REQUEST FOR INFORMATION **DATE:** July 06, 2017 **NO.:** RFI-583

Project Name: 15051-Webster University Interdisciplinary Science Building Project No.: 15051

Subject: Wiremold Conflict with Plumbing Clean-out and Drench Hose in Room 391

9 L03 ANATOMY/ PHYSIO LAB - NORTH

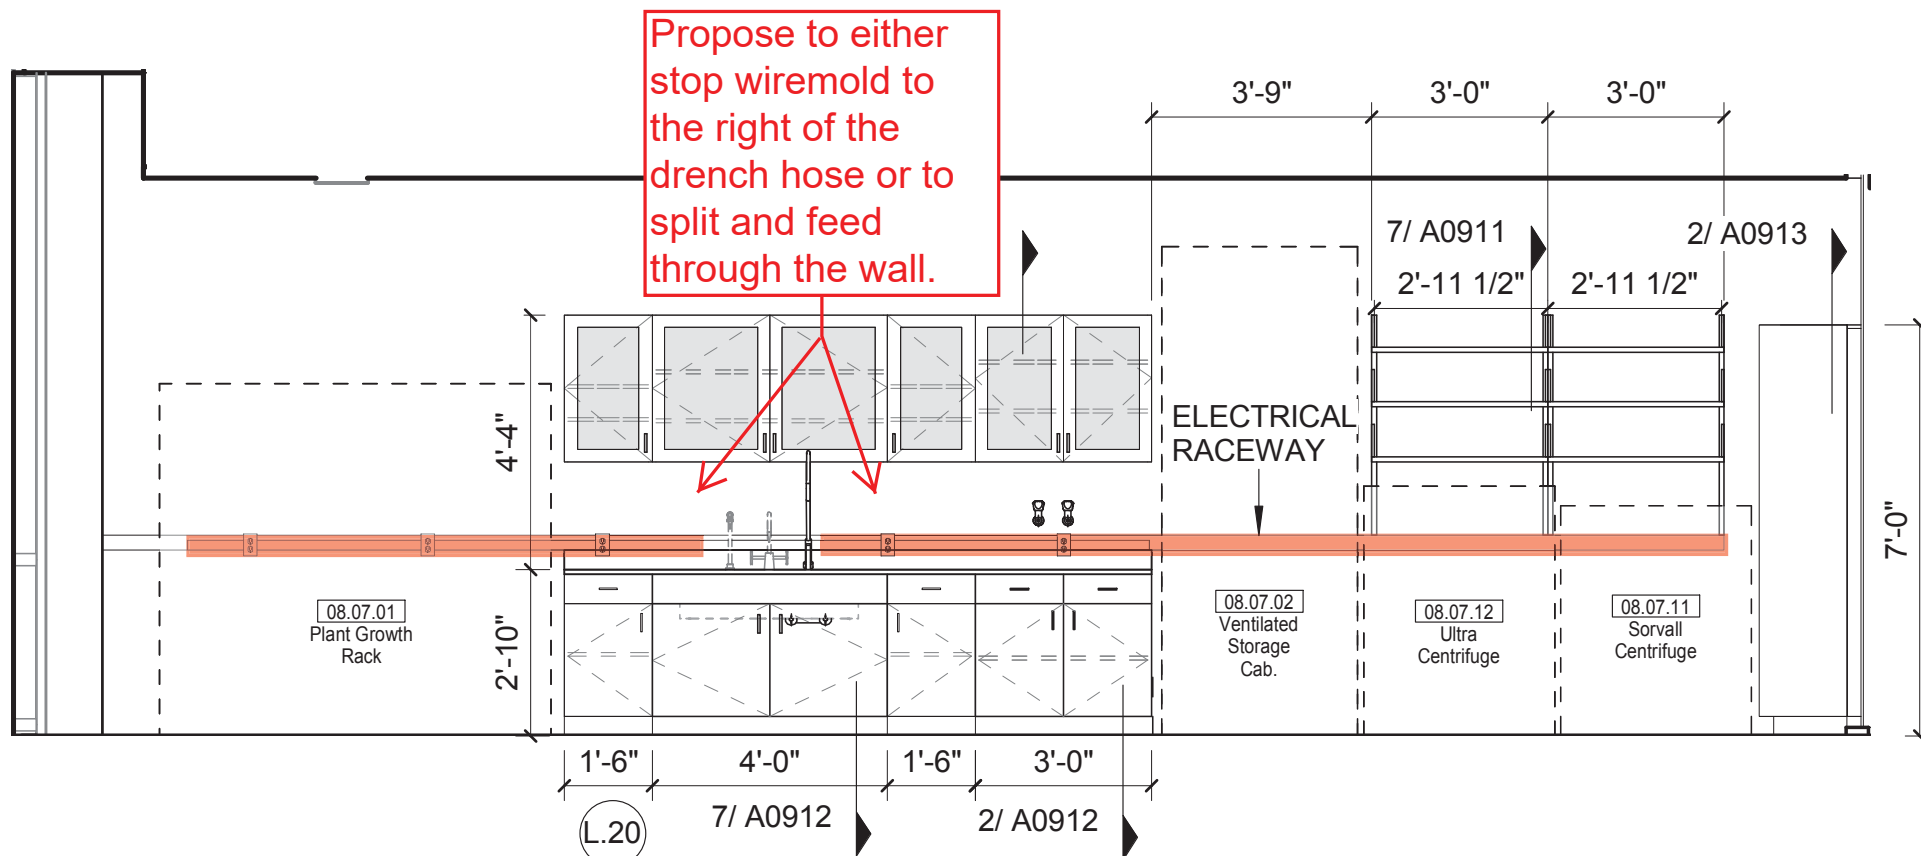
The plumbing cleanout had to be placed at its current location due to a steel "X Brace" behind the wall. This cleanout now conflicts with the wiremold. This sink has a drench hose, which also conflicts with the wiremold. See attached photos.

Suggestion: Paric proposed the two following solutions;

1. Terminate the wiremold at the east (right) of the drench hose (preferred)
2. "Break the wiremold" at the conflict locations and run the wires behind the wall (additional labor and rework, see attached sketch)

REPLACE THE WIREMOLD WITH ELECTRIC OUTLETS PER RFI-585 RESPONSE.
